### **Proposal for Supplement 21 to the 01 series of amendments to UN Regulation No. 53 (Installation of lighting and light-signalling devices for L<sub>3</sub> vehicles)**

#### **Submitted by the Working Party on Lighting and Light-Signalling\***

## Supplement 21 to the 01 series of amendments to UN Regulation No. 53 (Installation of lighting and light-signalling devices for L<sub>3</sub> vehicles)

**Observing area towards the apparent surface of exterior courtesy lamps**

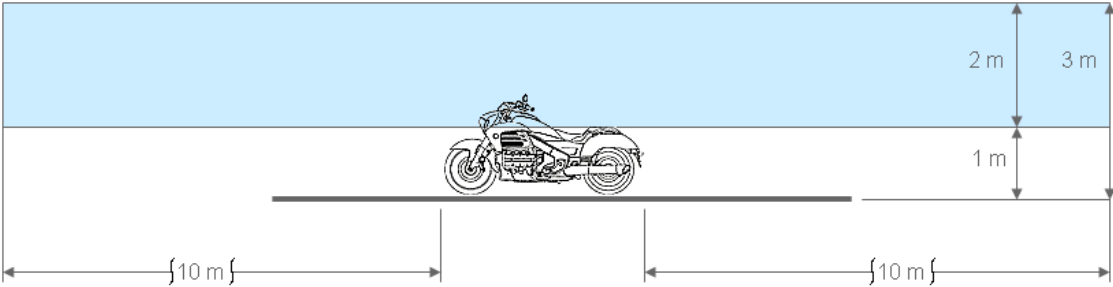
Insert a new Annex 7, to read:

This drawing shows the zone from one side, the other zones are from the front, the rear and from the other side of the vehicle.

- 6.15.9.3. The technical service shall, to the satisfaction of the Type Approval Authority, perform a visual test to verify that there is no direct visibility of the apparent surface of the exterior courtesy lamps, if viewed by an observer moving on the boundary of a zone on a transverse plane 10 m from the front of the vehicle, a transverse plane 10 m from the rear of the vehicle, and two longitudinal planes 10 m from each side of the vehicle; these four planes to extend from 1 m to 3 m above and perpendicular to the ground as shown in Annex 7.
